PROPOSED REFINEMENT TO MASTERPLAN 2030

DRAFT SYDNEY OLYMPIC PARK MASTER PLAN 2030 (2016 REVIEW) AND
DRAFT AMENDMENTS TO SEPP (STATE SIGNIFICANT PRECINCTS) 2005

November 2016

Diagram 6

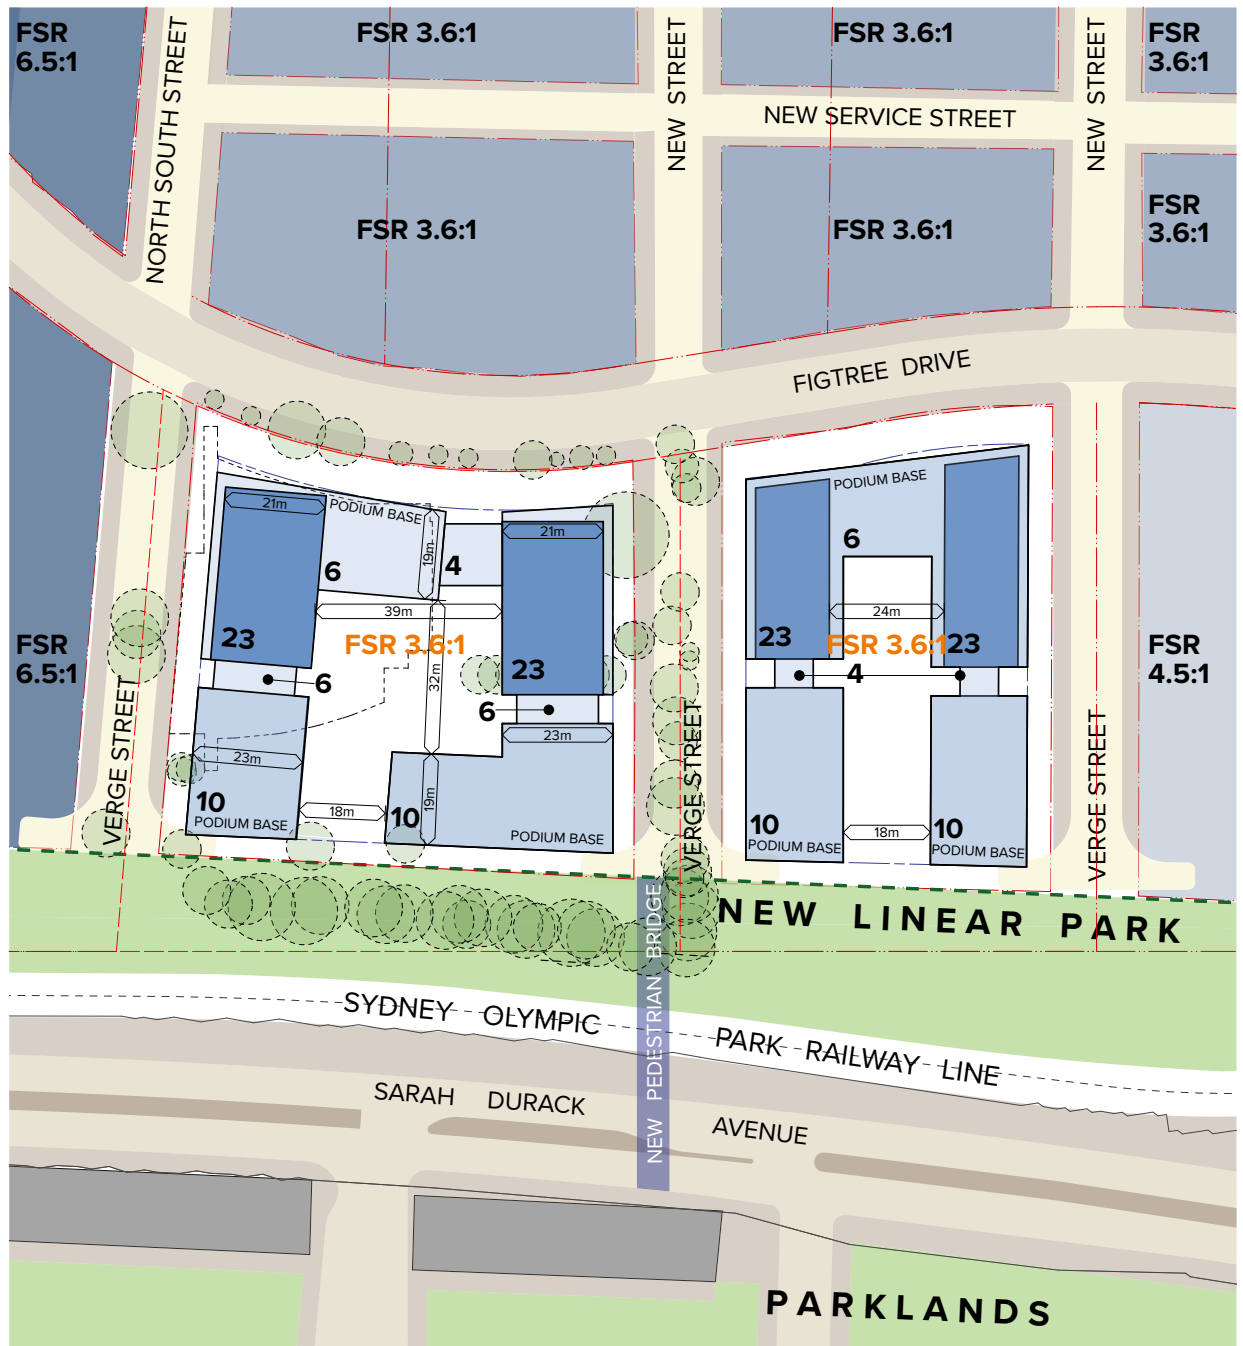
In terms of building design, an FSR of 3.6:1 could be readily achieved, whilst also complying with all the relevant development controls. This includes building separation, setback and the tower-profile criteria required for new residential block developments. In addition, all new development incorporating this FSR could be designed such that any off-site impacts could be fully mitigated, including any impact upon existing or future neighbouring buildings. Refer to Diagram 6.

Future Masterplan can accommodate FSR 3.6 : 1 within height controls in line with FSR control to adjacent sites for consistency across the Precinct.

As the accompanying drawings by Turner show, the site potential to accommodate density is considerable. An FSR of 3.2:1 represents a missed opportunity to facilitate density at appropriate locations and restricts the Site's capability to provide future growth. We consider that an FSR of 3.6:1 to be more appropriate for the Site.

Diagram 7

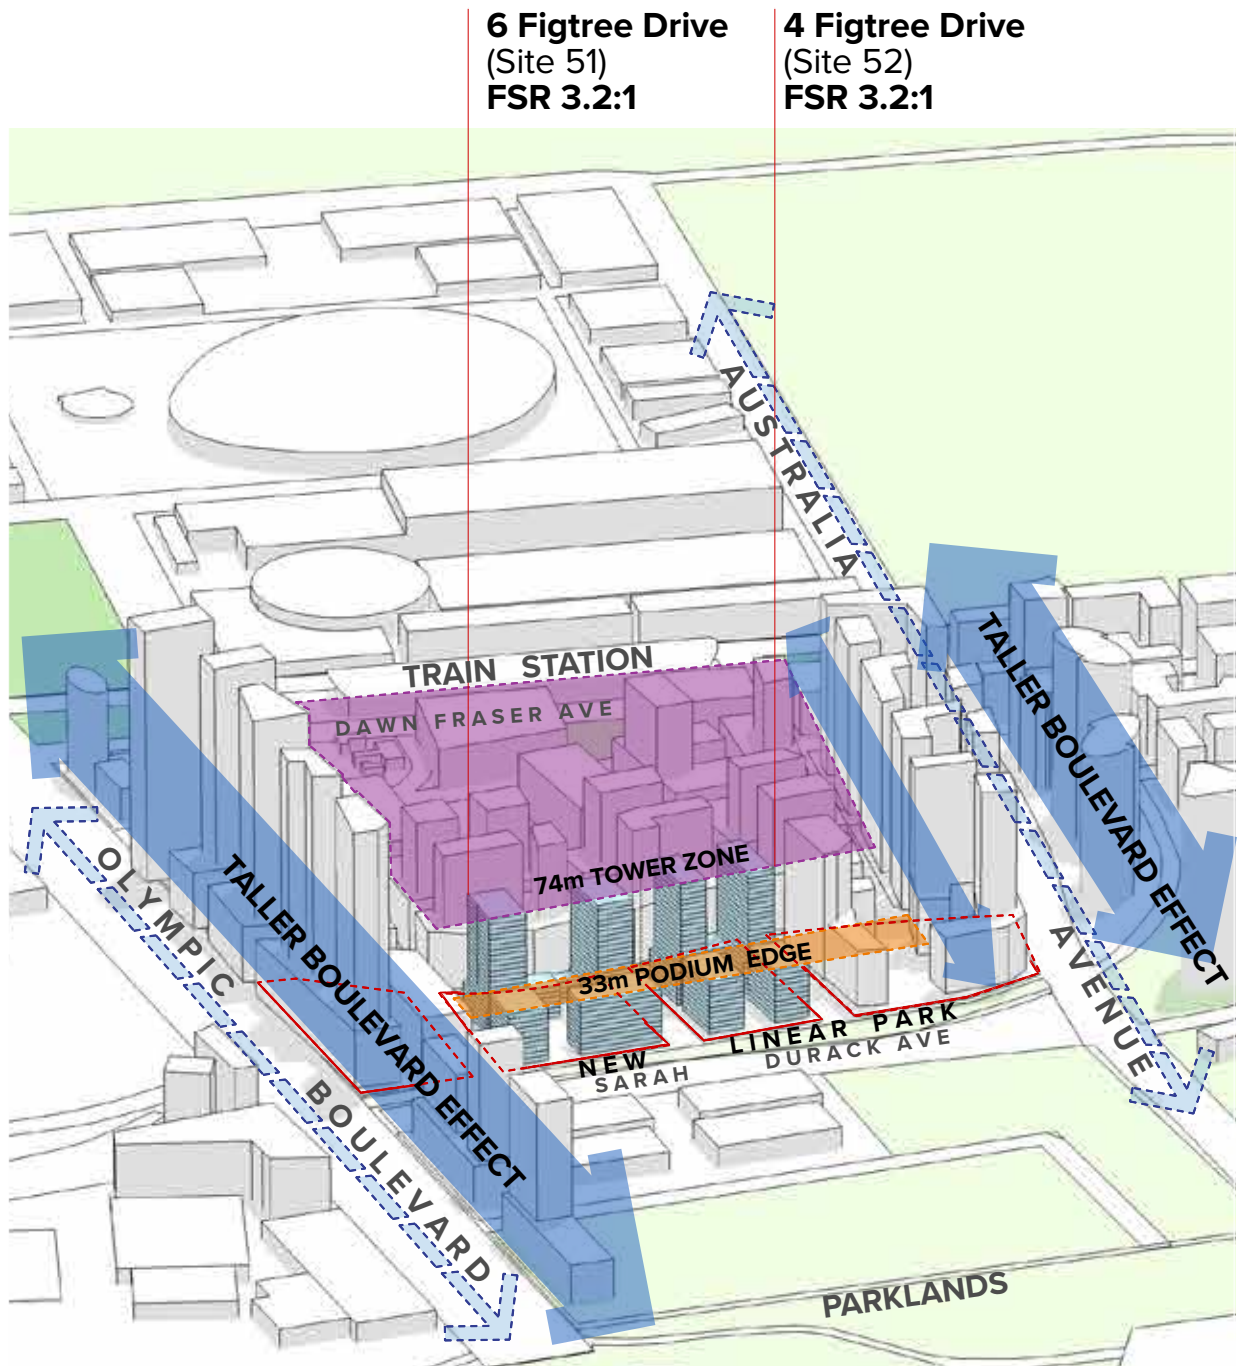
The exhibited height controls propose to amend heights across the Central Precinct, including the Site. Previously, the applicable height control was for 10 storeys across the block. As illustrated in Diagram 7, the maximum heights have been allocated for the sites along Australia Avenue and Olympic Boulevard, and a new split height limit for Sites along Figtree Drive.

The proposed controls introduce a split height limit of 8 storeys on the southern portion of the Site which fronts the new linear park and 20 storeys on the northern portion. There is also a proposed block edge variation control of 4-8 storeys (as shown in Diagram 5).

Whilst the increase in the height control on part of the site is welcomed and aligns with the updated strategy in the Master Plan, the introduction of a split control across the site is not conducive to good architectural outcomes.

Split height controls (of 33m and 74m) limits variety to architectural bulk, scale and form.

Our view is that a single height control across both Site 51 and Site 52 will create a consistent and improved architectural outcome for the Precinct. This can easily be achieved by simply setting the height at 74 m for the entire site.

Diagram 8

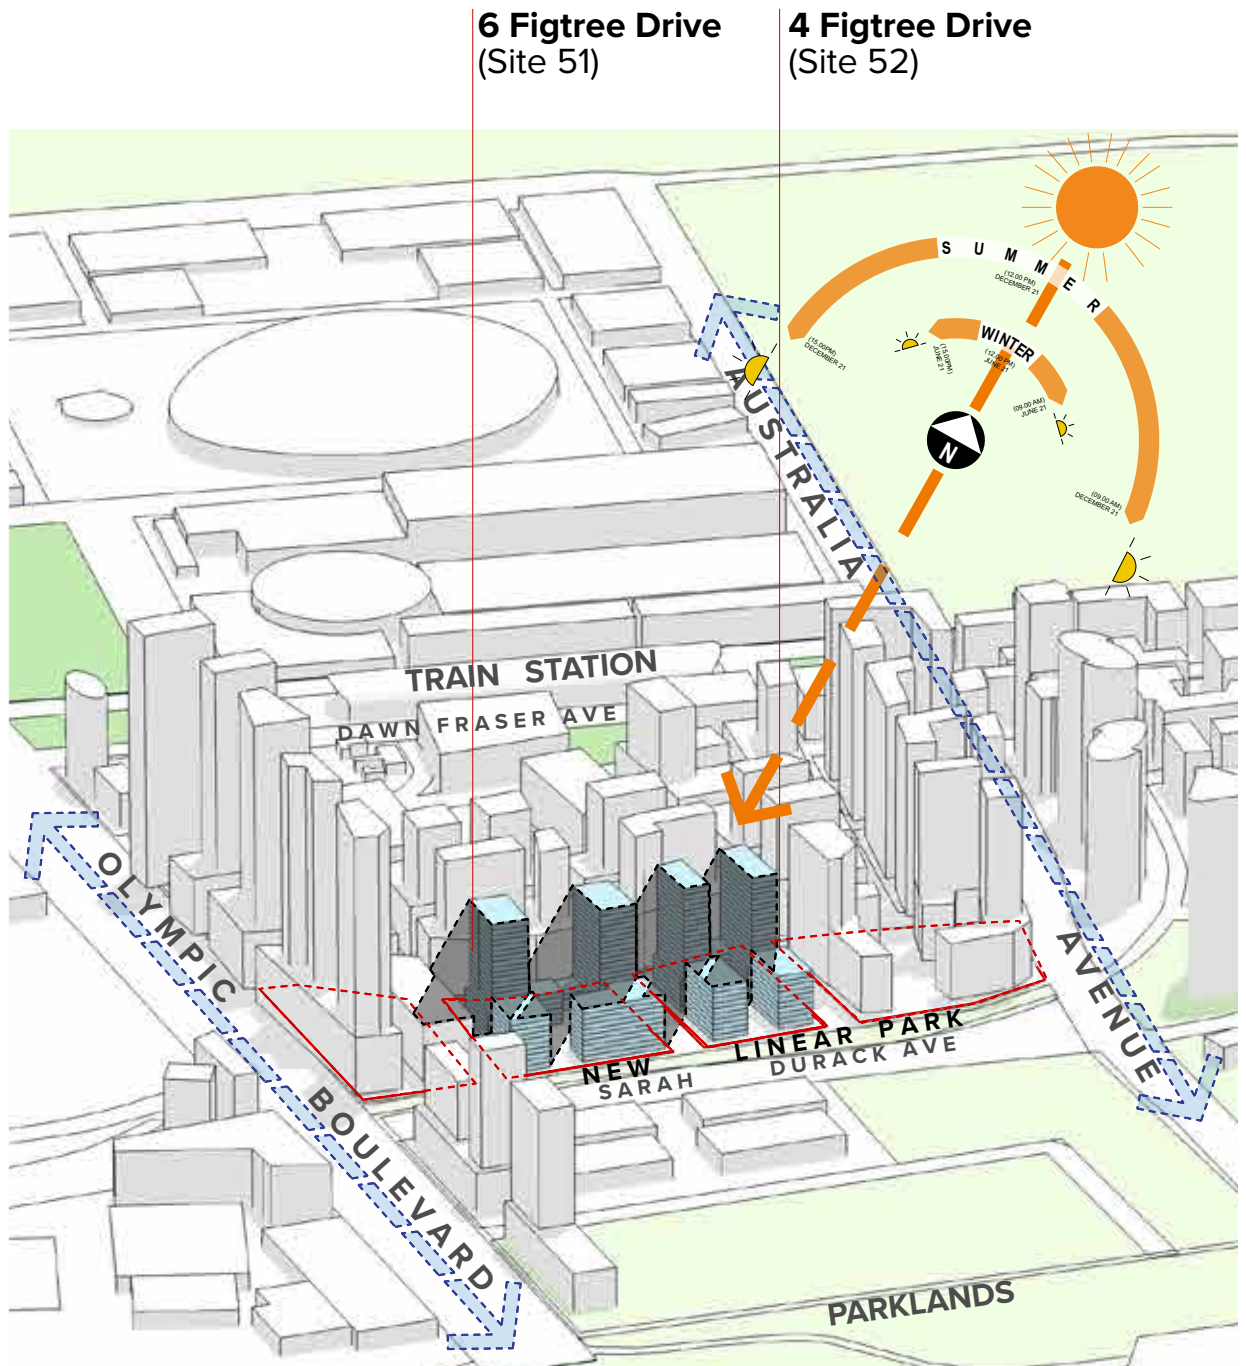
If greater flexibility was afforded to the design, a new tower on the Site for example, which is taller at the southern part of the Site would better avoid any shadowing at the Site and its surrounds. This should be strongly considered as it would be highly beneficial for the amenity levels of future residents. It would also help to create a more sympathetic built form that is much more consistent with the overall character of Figtree Drive. It would also better reflect and reinforce the designated view corridors as set out in the exhibited Master Plan across Olympic Park.

Taller buildings to the north overshadow lower buildings to the south, counter to ADG objectives for solar access.

Diagram 9

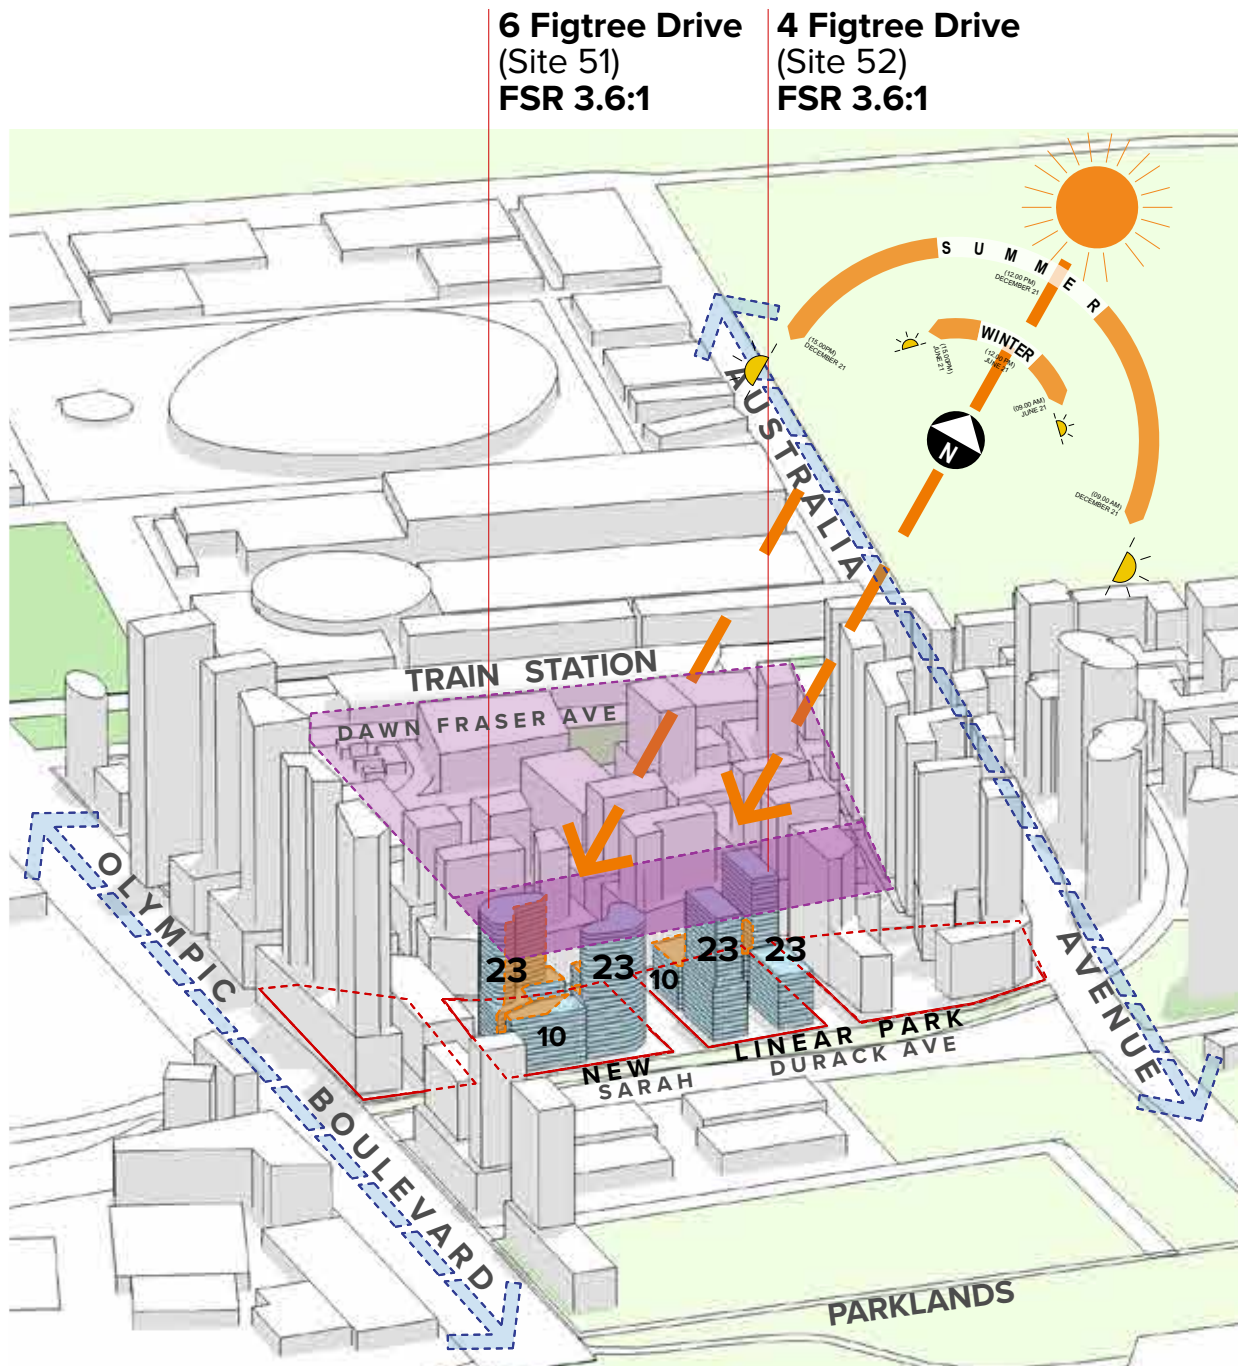
This form of height control introduces an avoidable constraint on the future design of any building at the Site. Turner have prepared a set of illustrative plans which demonstrate that appropriate massing is better achieved without these artificial split level controls at the Site. Single controls are more logical and would better serve the Master Plan principles for the precinct without the need for restrictive and introduced complexities to height control. Refer to Diagram 9 and 10.

Provision of a single height limit (of 74m) across the site provides flexibility for improved solar access and variety of bulk and scale in response to the surrounding context.

Diagram 10

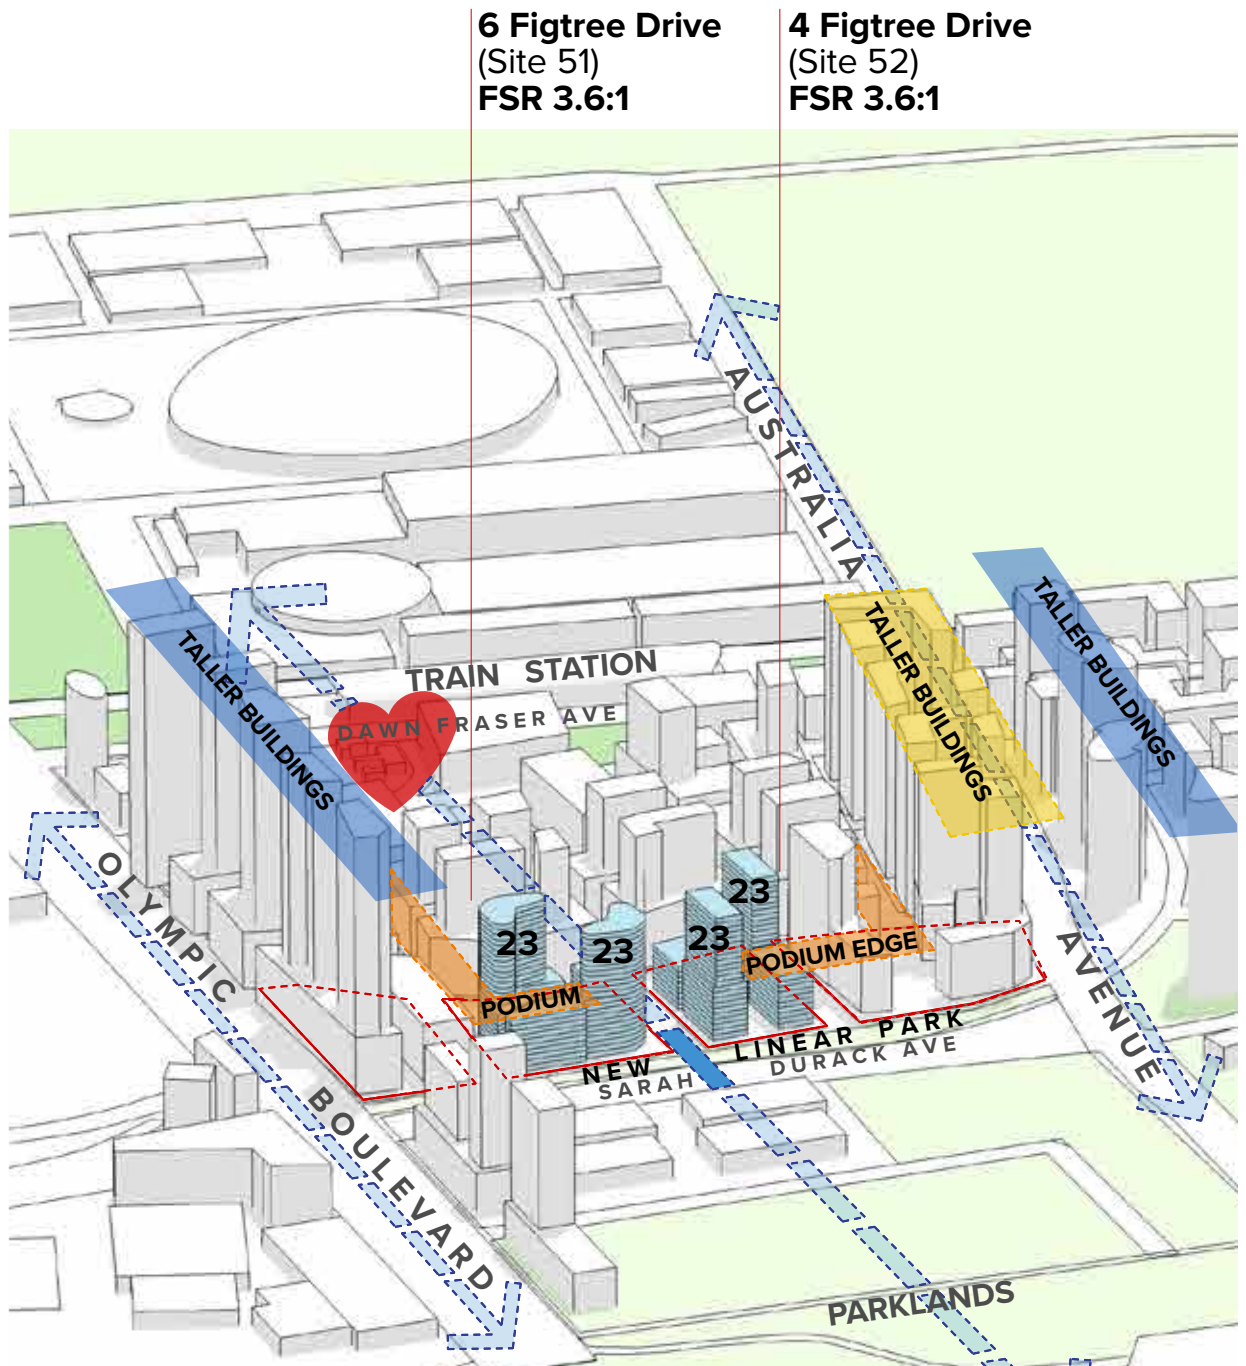
It is recognised that a new pedestrian connection is proposed across Sarah Durack Avenue that is intended to land immediately to the east of the site, in proximity to the new street proposed between sites 51 and 52 within the Central Precinct. Diagram 10 identifies the positioning of the bridge in context to the Site.

This will serve to create a key nodal point at this location, which will better connect the Central Precinct with the Boundary Creek Precinct and accommodate future pedestrian flows. Such a solution would fit far better with a taller building across the Site and will better address the new pedestrian bridge and provide a 'sign-posting' development as a reference point for future bridge users.

Taller building forms adjacent to new pedestrian bridge reinforces north-south alignment of new connection to the town centre.
